SP2026-001: Amended Site Plan for Layne's Chicken at 1801 S. Goliad Street

PROJECT NUMBER: SP2026-001
PROJECT NAME: Amended Site Plan for 1801 S. Goliad Street
SITE ADDRESS/LOCATIONS: 1801 S. Goliad

TO: Planning and Zoning Commission
FROM: Bethany Ross, *Senior Planner*
DATE: February 10, 2026
SUBJECT: SP2026-001; *Amended Site Plan for Layne's Chicken*

SHEET
A.203

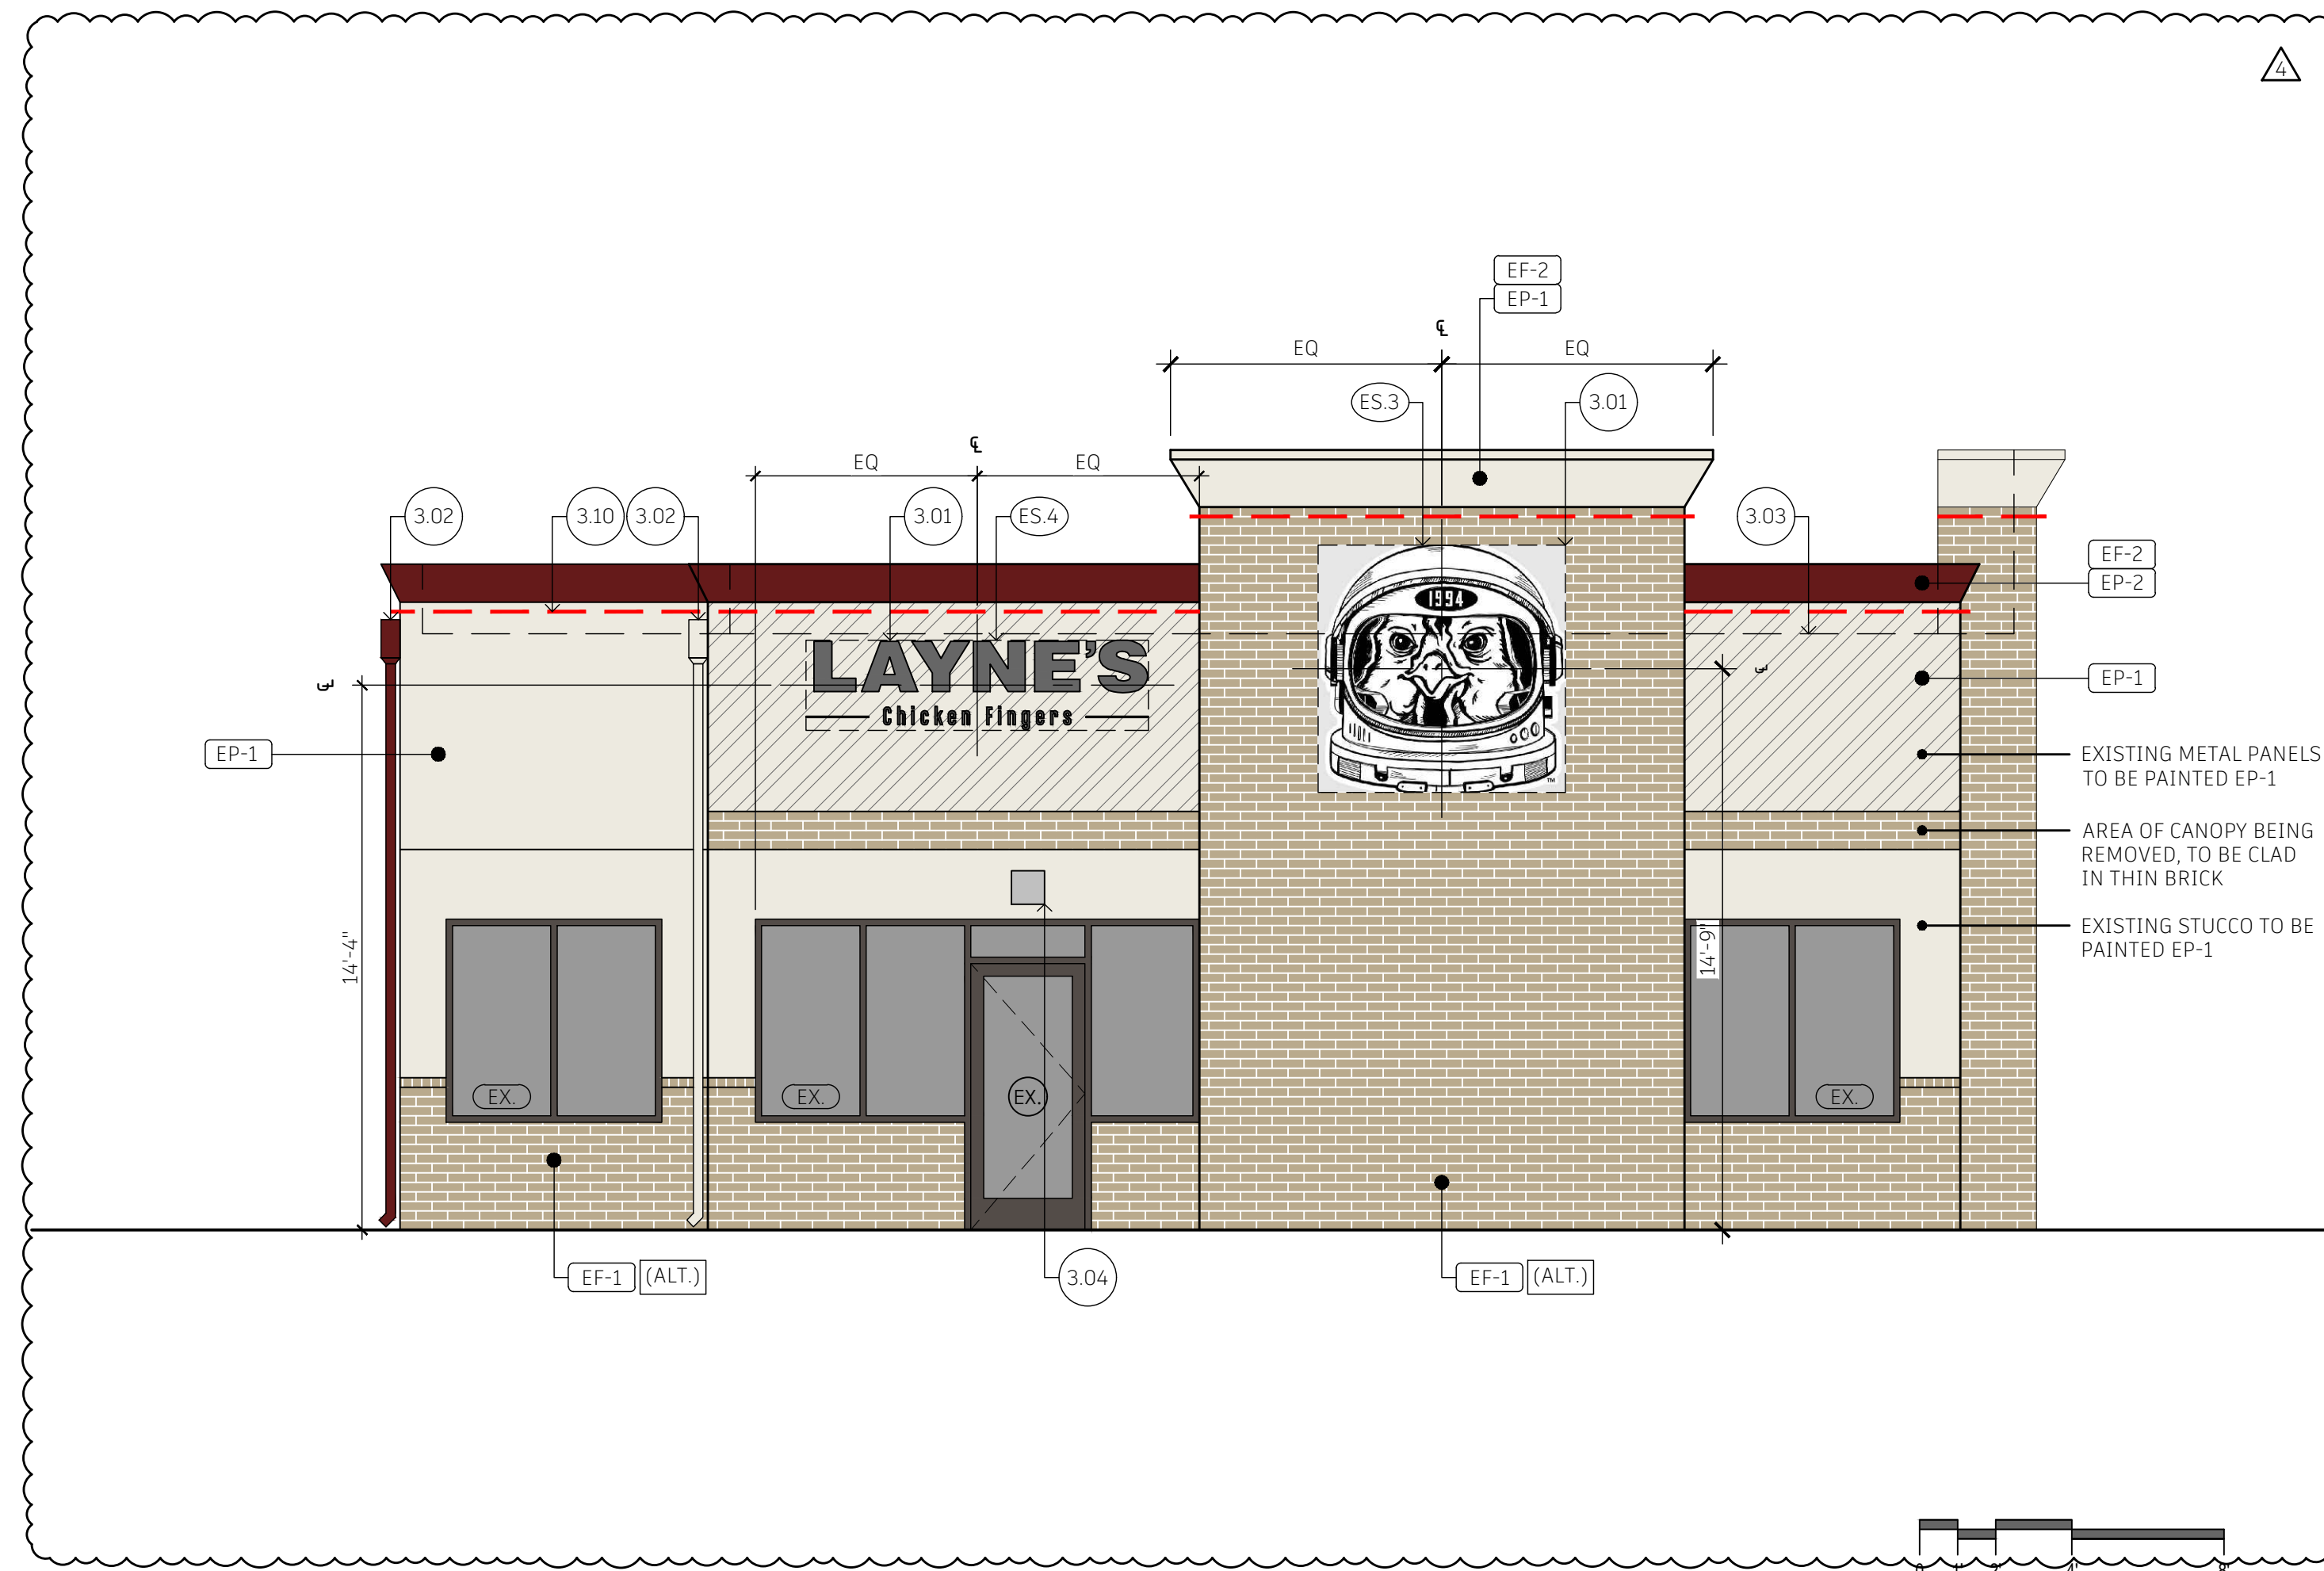
M.5 The applicant is requesting to remove the Stone on the building and replace it with brick. In doing this, the applicant is requesting a variance to the 20% stone requirement of the General Overlay District Standards. According to 06.02 (C), Architectural Standards, of Article 05, District Development Standards, of the Unified Development Code (UDC), (a) minimum of 20% natural or quarried stone is required on all building façades. This will require a variance from the Planning and Zoning Commission pending a recommendation from the Architectural Review Board (ARB).

SHEET A.204

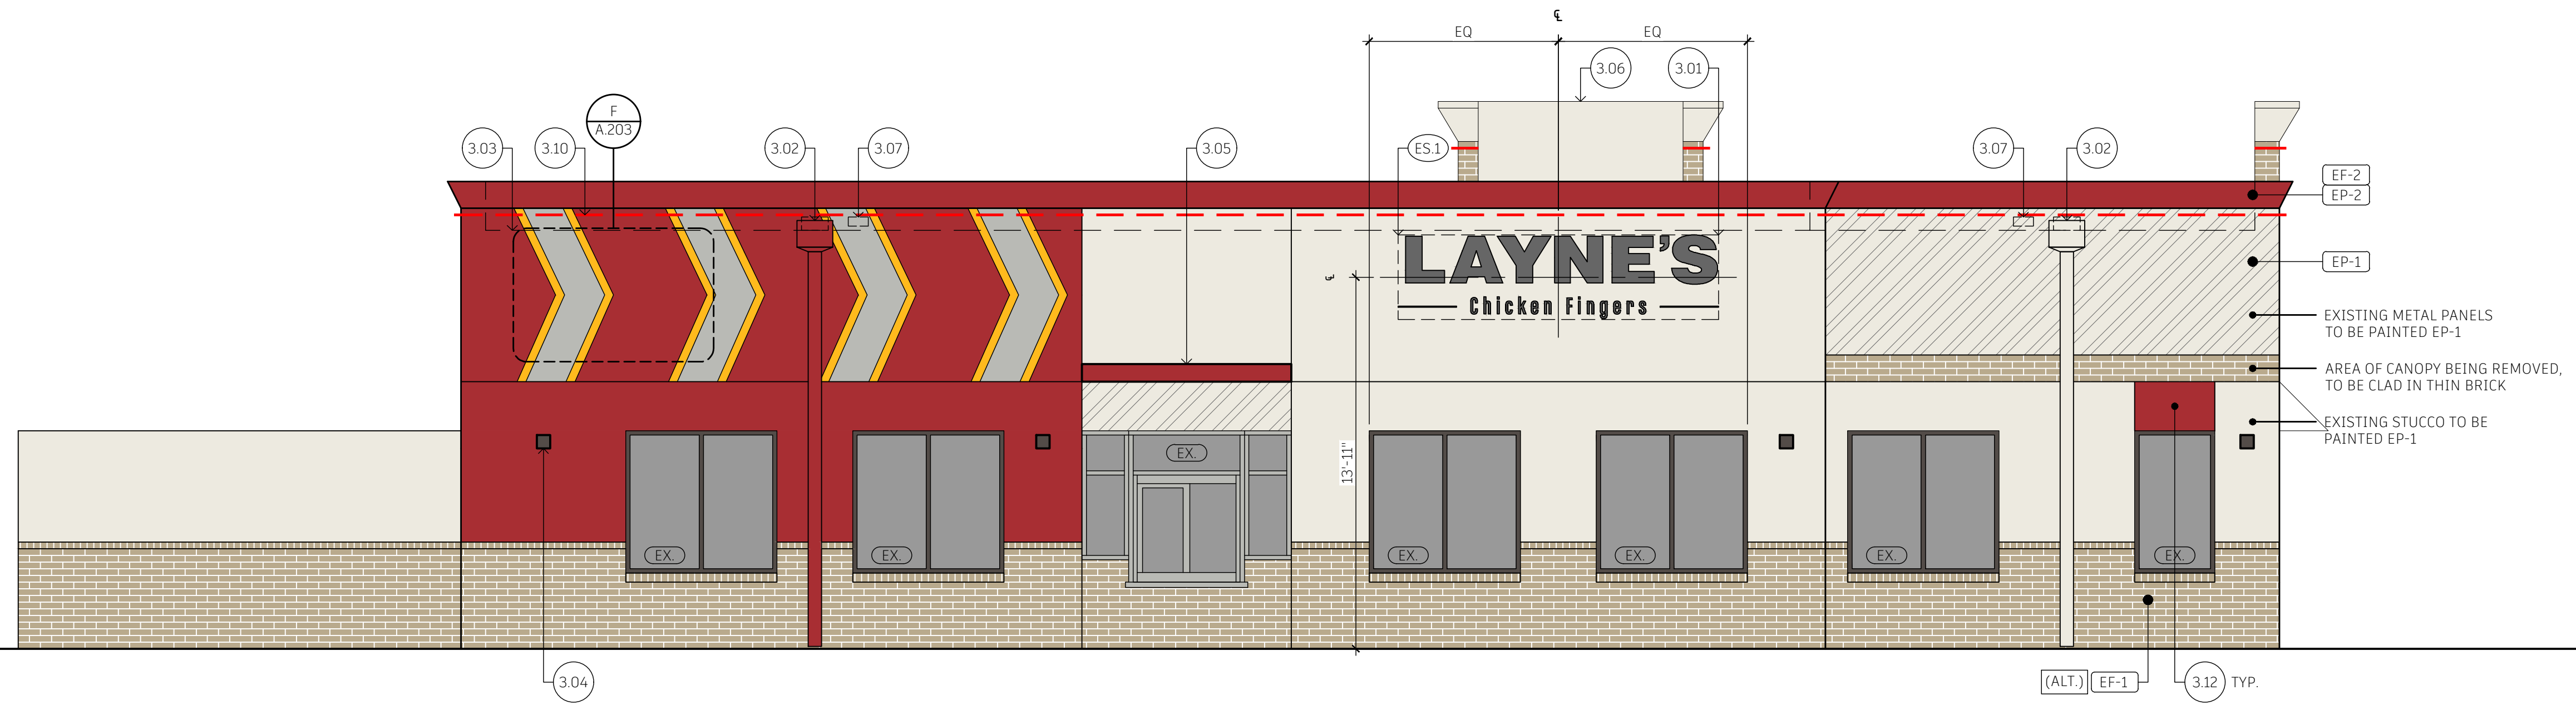
The proposed *Amended Site Plan* removes all existing stone elements from the building façade and replaces them with a thin-width brick product. While brick is generally considered a high-quality masonry material, the proposal to eliminate the minimum 20.00% natural or quarried stone required by Subsection 06.02(C), *Architectural Standards*, of Article 05, *District Development Standards*, of the Unified Development Code (UDC) represents an additional variance for the property. The current request does not propose an alternative stone material, but rather the complete removal of the stone in favor of additional thin-width brick.

On January 27, 2026, the Architectural Review Board (ARB) reviewed the building elevations and provided a recommendation to the applicant that metal arcade elements be reintroduce where the existing fabric canopies were on the building facades, and stating that they were generally not opposed to the incorporation of the thin-width brick in lieu of the natural stone. On February 3, 2026, the applicant provided staff updated building elevations reflecting the reincorporated fabric canopies. The Architectural Review Board (ARB) is scheduled to review the updated elevations prior to the Planning and Zoning Commission meeting on

PHOTOMETRIC PLAN
 SCALE: 1/12" = 1'-0"

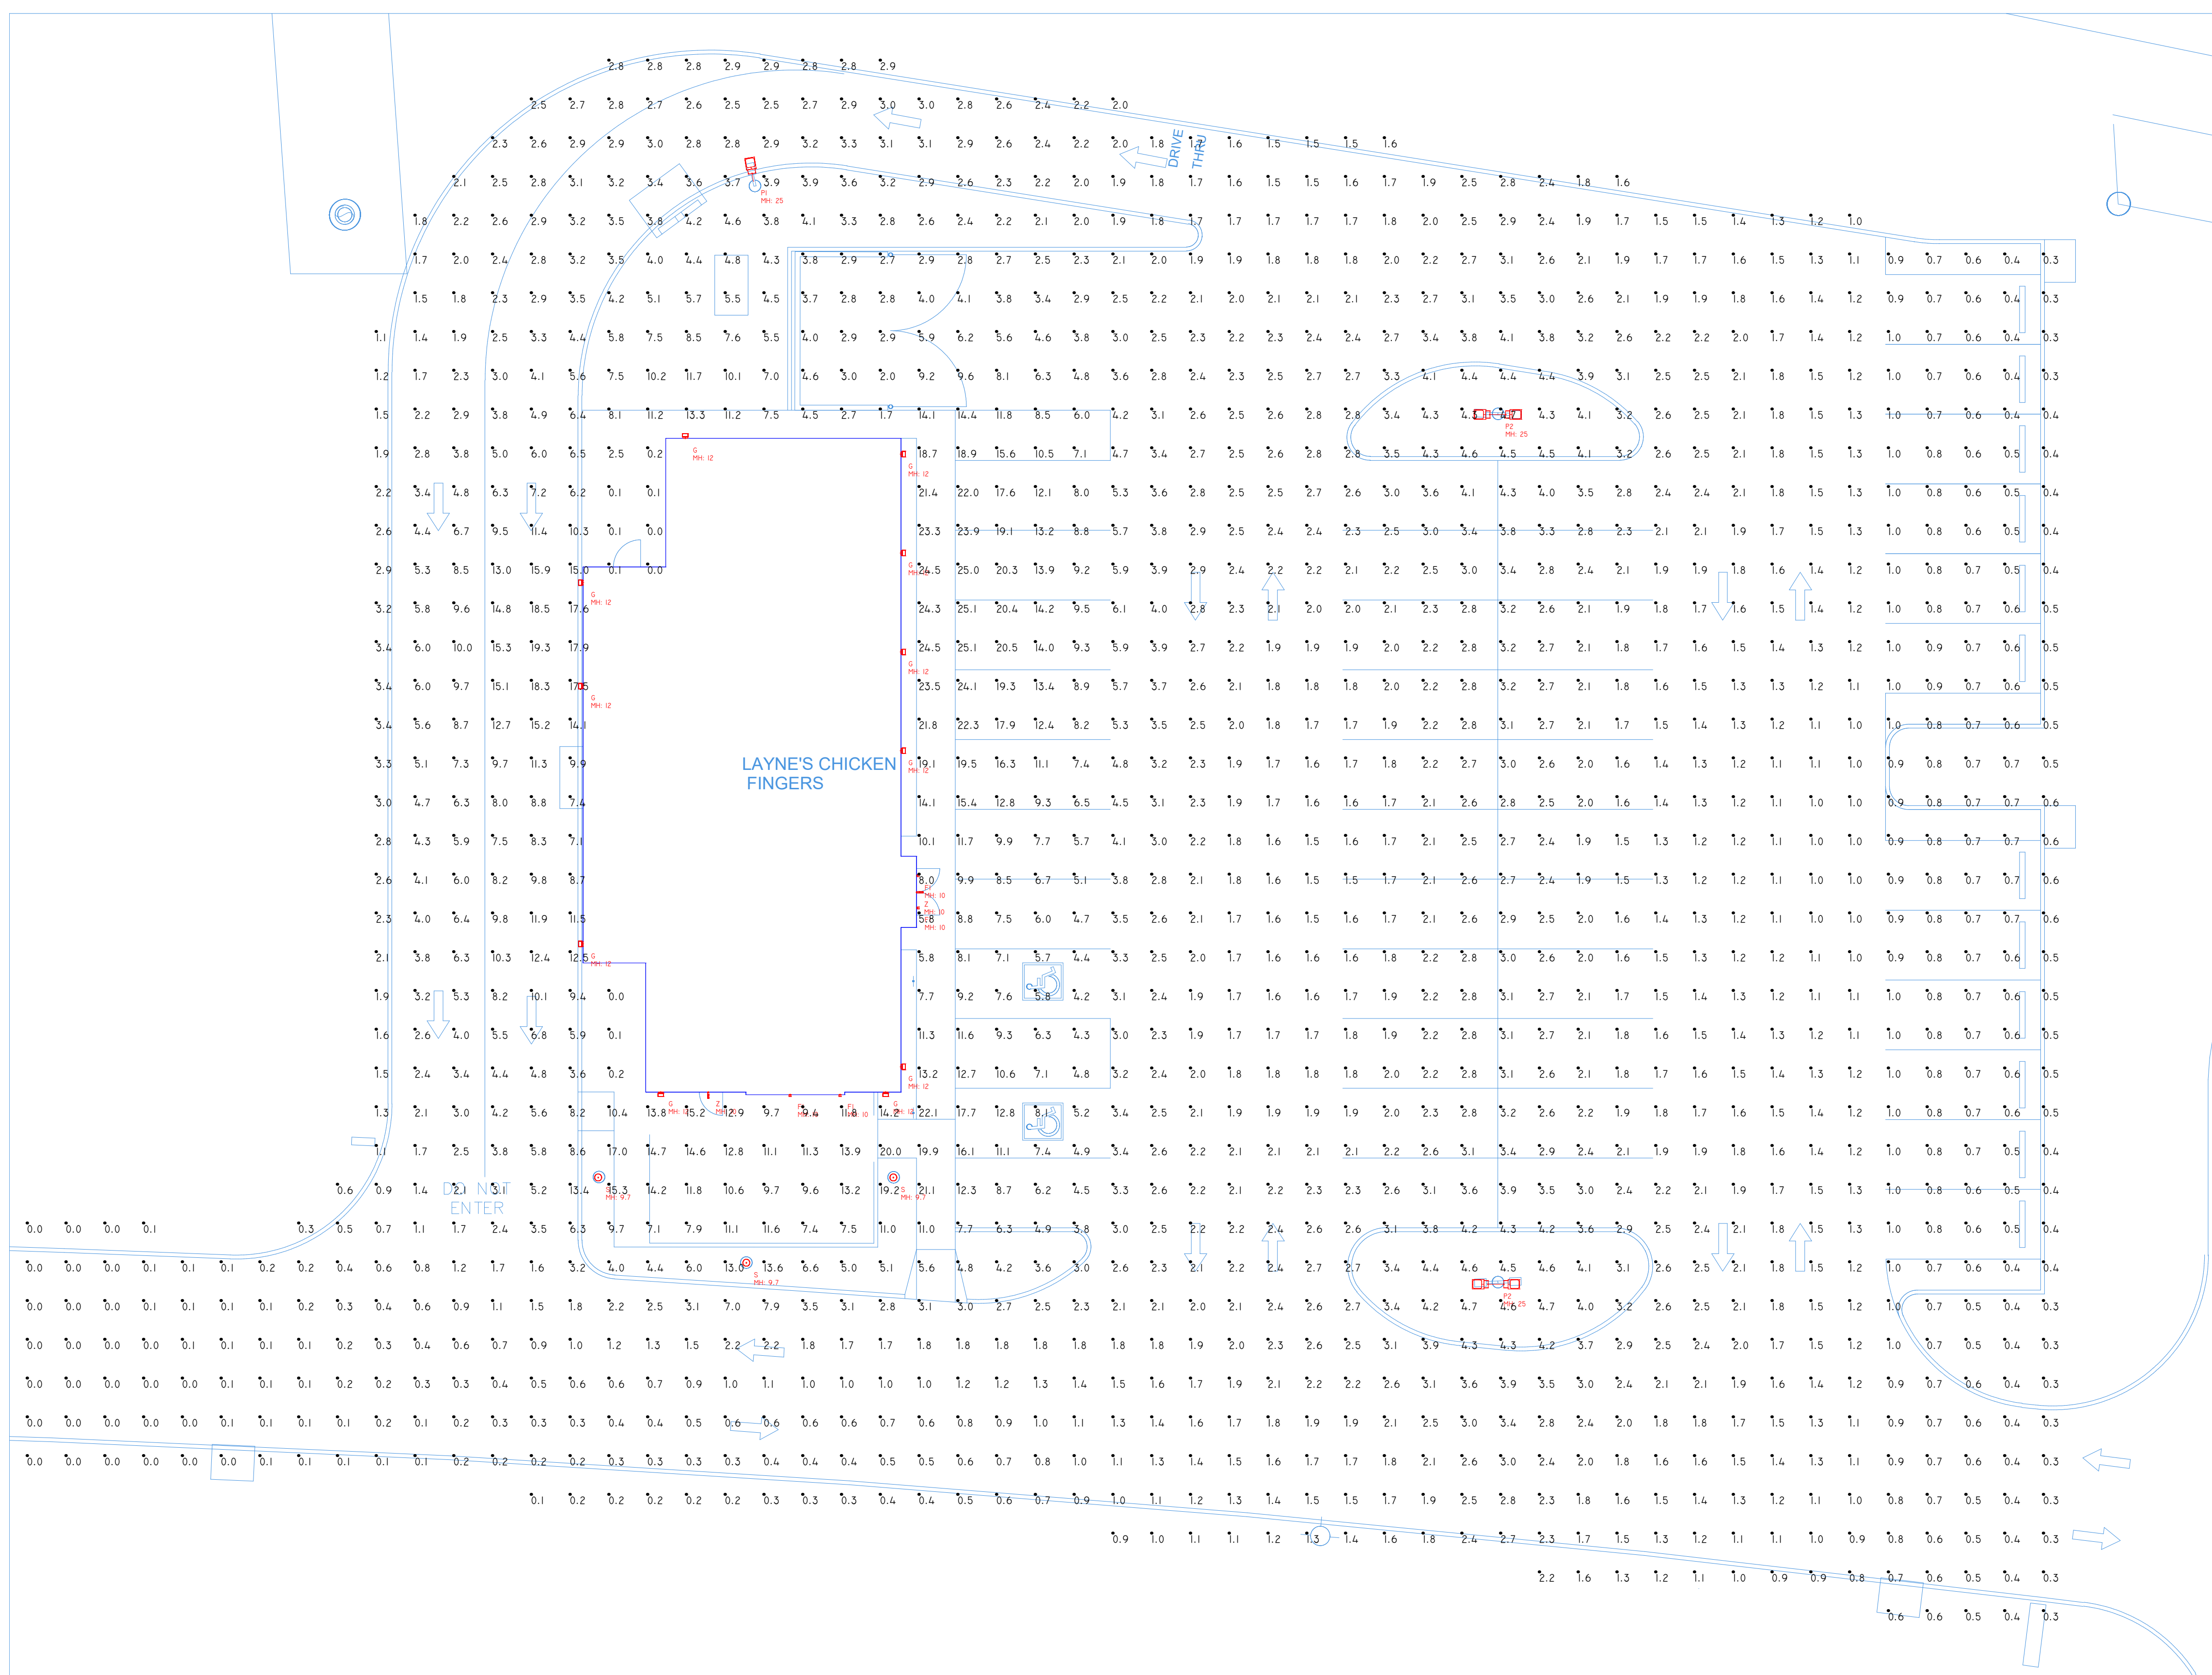
However, staff will need to see a landscape plan that shows the existing vs. expanded landscaping, and a photometric plan that meets the requirements of the Unified Development Code (UDC). The landscape plan should include a detail of the proposed fencing around the patio. Fencing in Commercial (C) Districts shall be wrought iron and a maximum of four (4) feet in height in front of the building.

- (1) The applicant provide an updated *Photometric Plan* that conforms to the lighting requirements of the Unified Development Code (UDC).
- (2) Any construction resulting from the approval of this Site Plan shall conform to the requirements set forth by the Unified Development Code (UDC), the International Building Code (IBC), the Rockwall Municipal Code of Ordinances, city adopted engineering and fire codes and with all other applicable regulatory requirements administered and/or enforced by the state and federal government.
